**TESTIMONY OF JOE MEHRA, P.E. PTOE, IN OPPOSITION TO THE 923-925 5<sup>th</sup> Street NW, Hotel, BZA Case No. 19722. (May 17, 2018)**

I have reviewed the Revised Comprehensive Transportation Review (CTR) study prepared by Gorove/Slade, dated May 4, 2018 and the response to my report submitted to BZA (response by Gorove/Slade is dated May 3, 2018) and DDOT Report dated May 11, 2018. Based on my review, I continue to conclude that the Gorove/Slade CTR is incomplete and does not meet the CTR Guidelines. Further, the Loading Dock access would not function based on the data and information provided by Gorove/Slade in their revised report.

PHOTO K

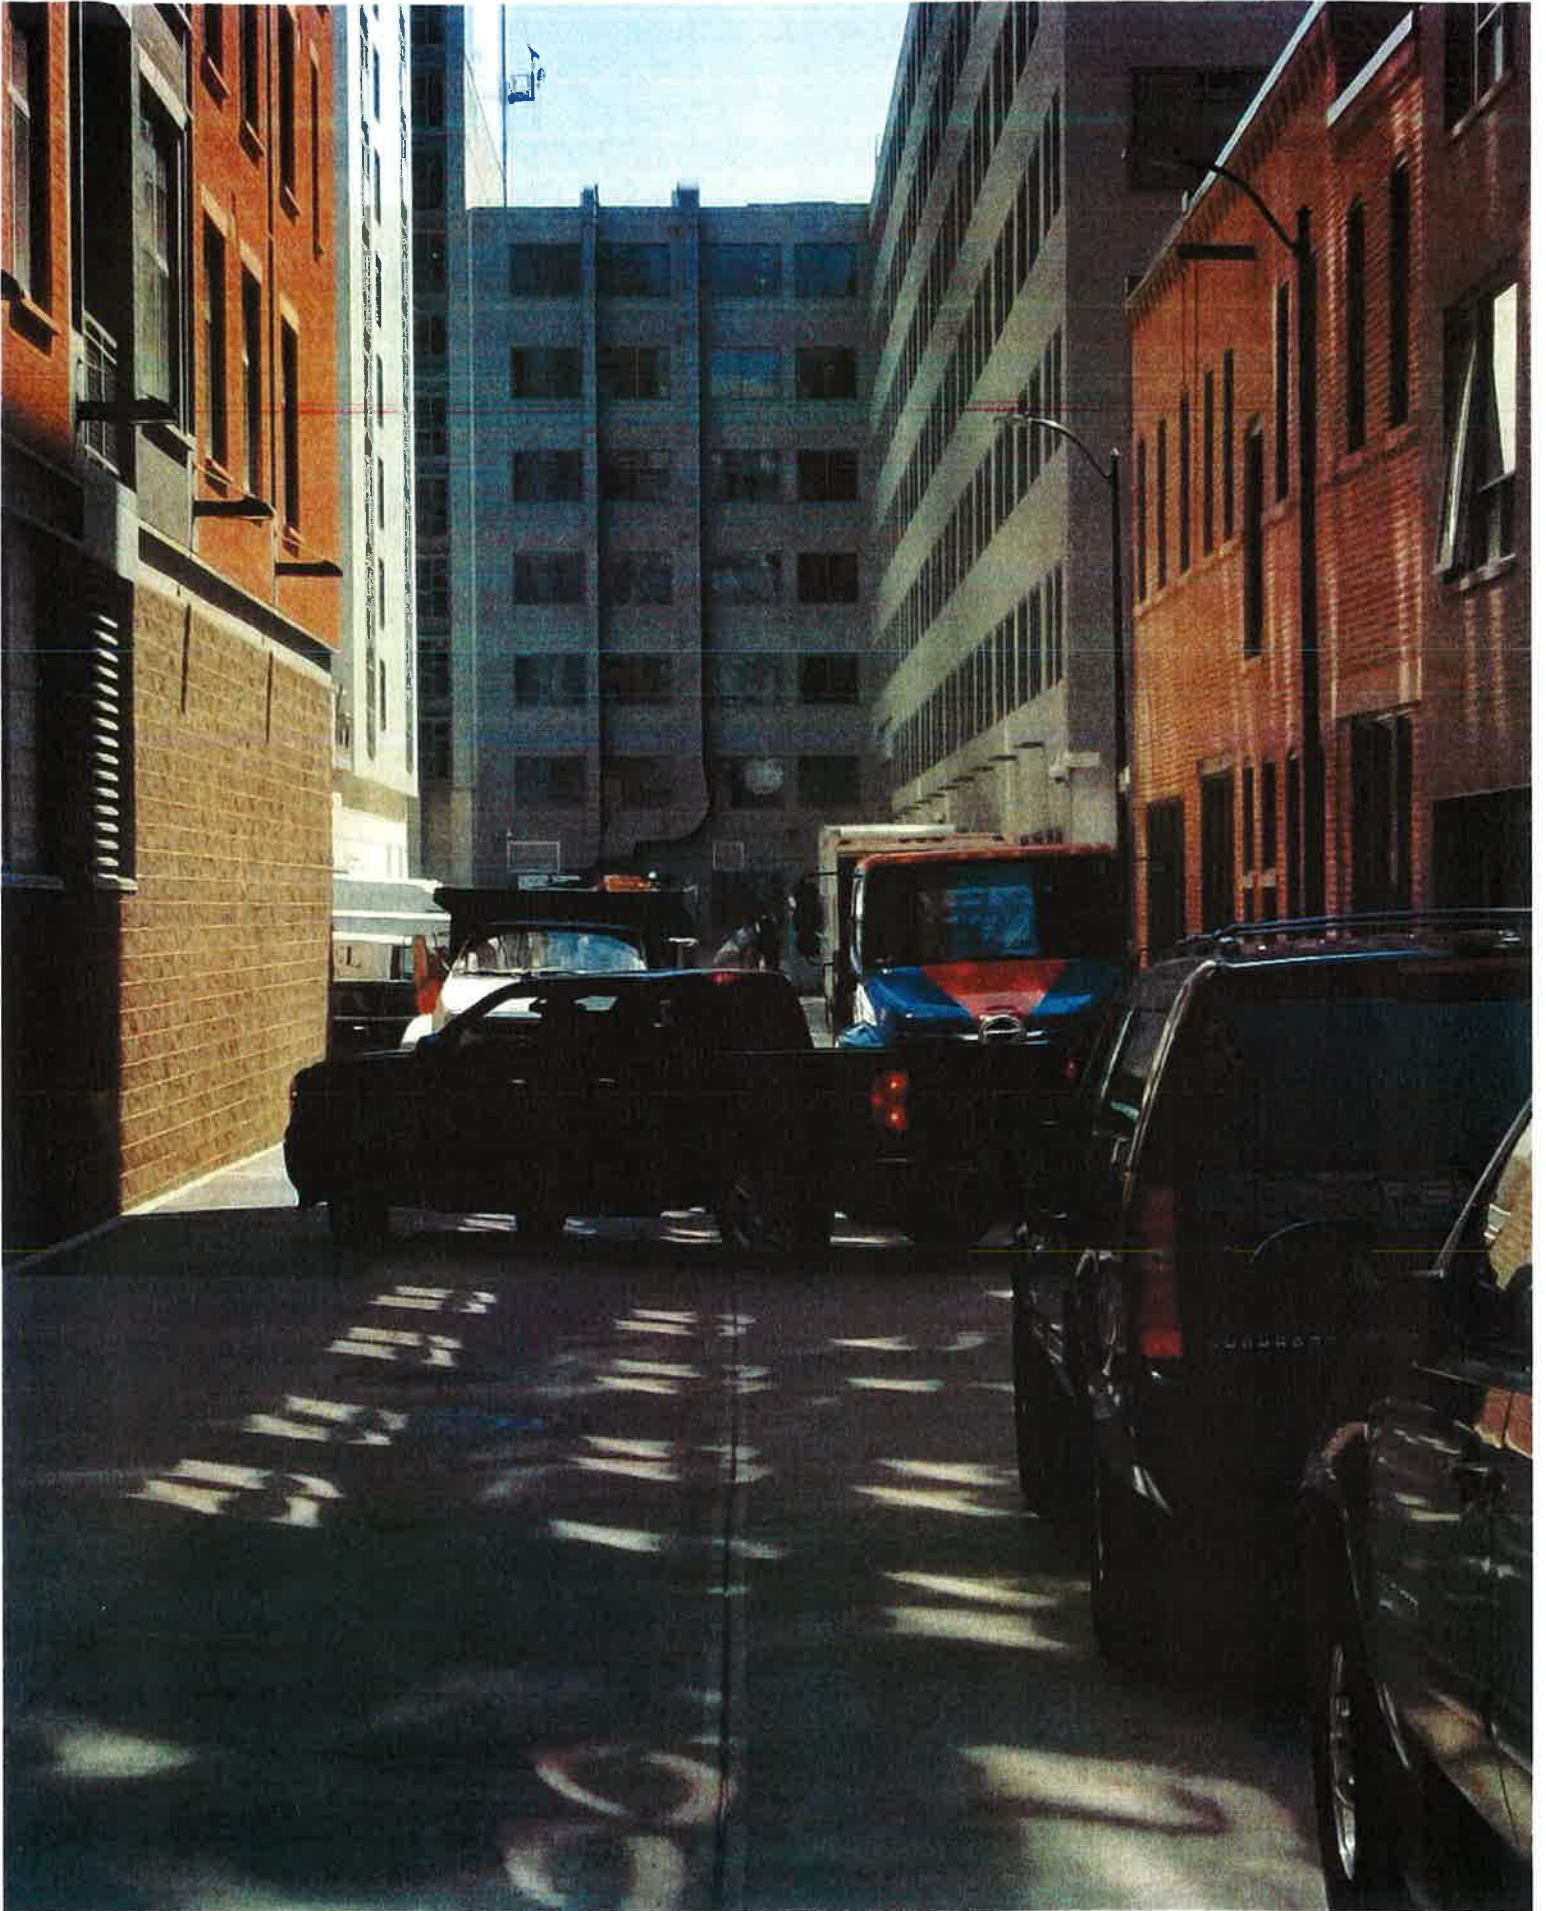
- J**     Truck blocking access to "hotel loading dock",
- K**     Access blocked to the hotel loading dock.
- L**     Access blocked to all vehicles on EW alley to hotel.

PHOTO N

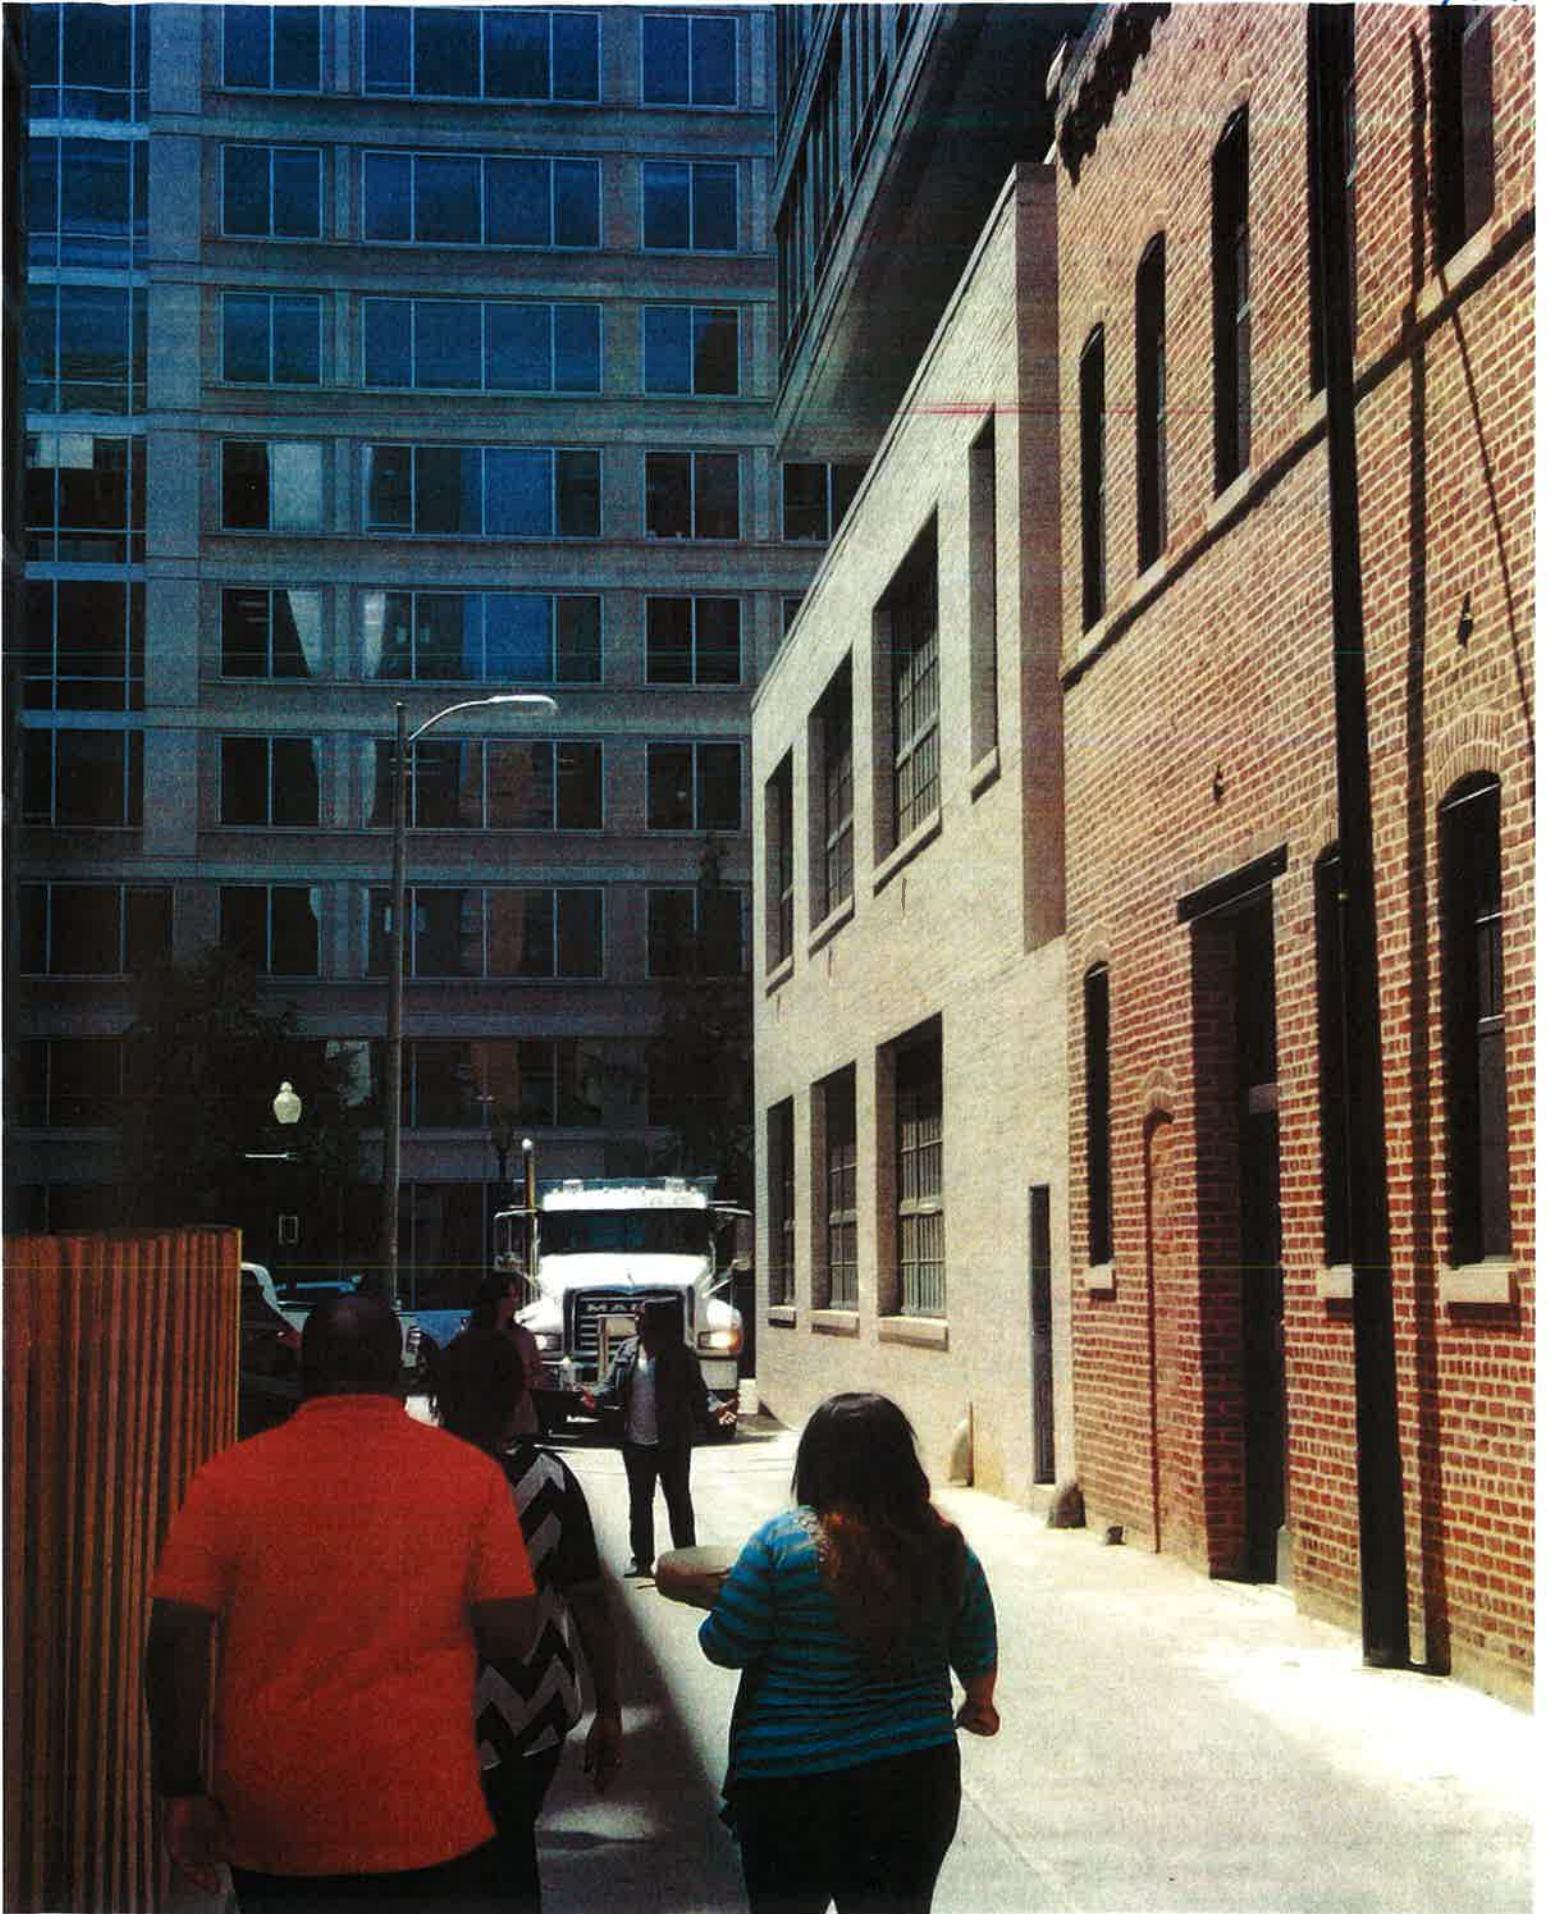
- M**     Need an assistant to guide trucks through alley.
- N**     Ped/vehicle activity along NS alley - path to hotel
- O**     Inches away from scraping the building.

PHOTO P

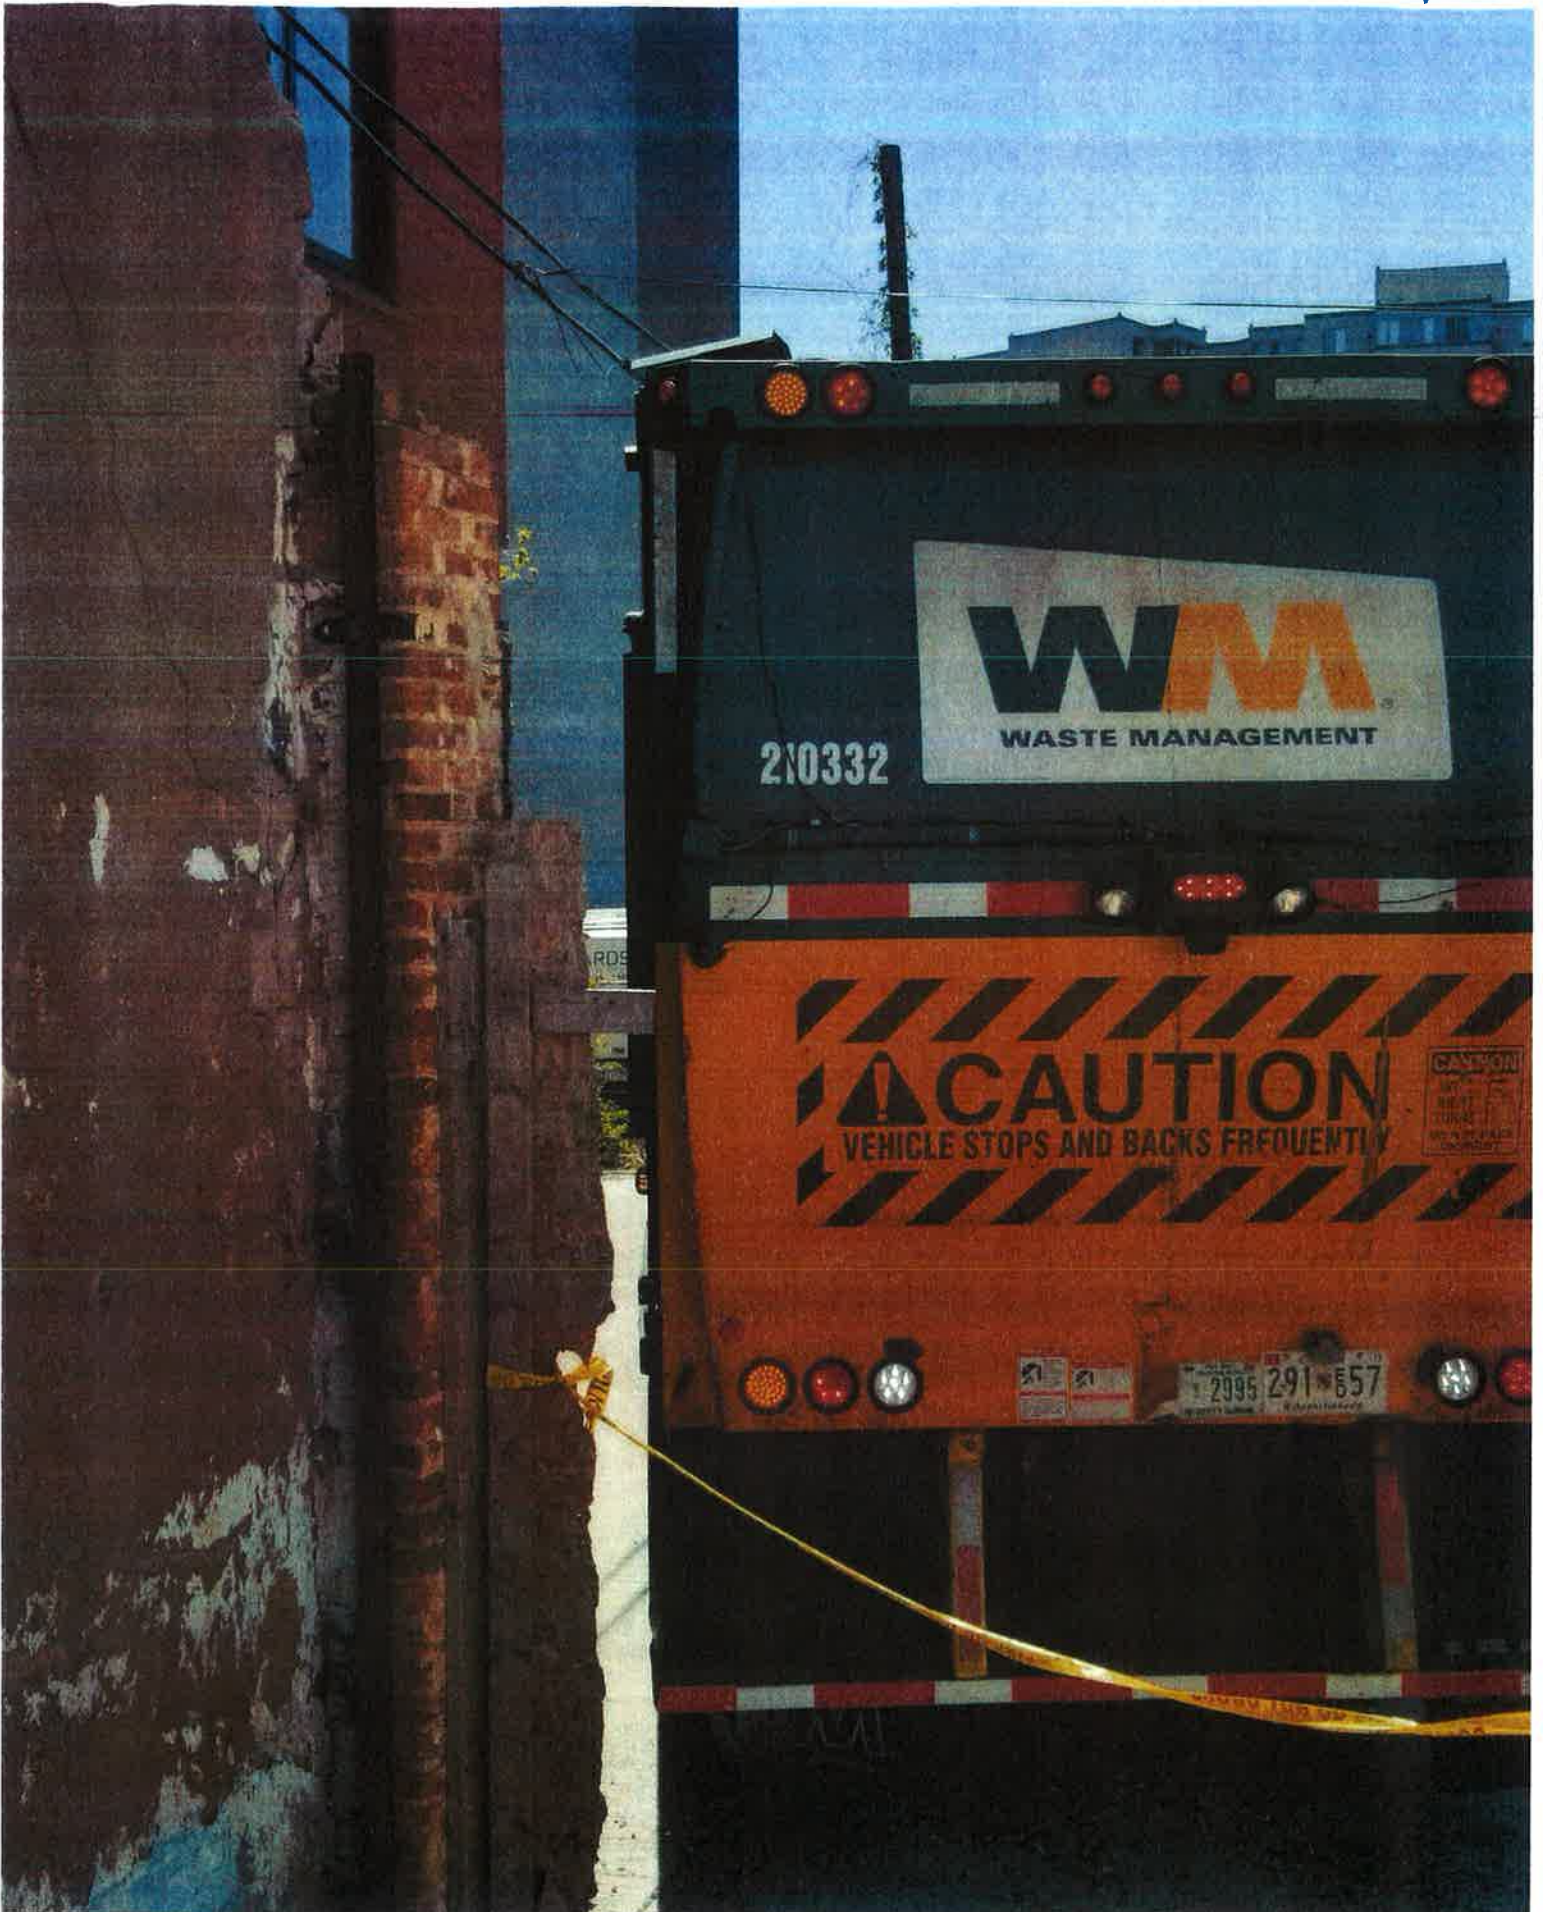
- P**     Truck backing into the loading dock area with assistant.
- Q**     Margin of error backing into the hotel loading dock.
- R**     Trash truck driver waiting to leave the area.
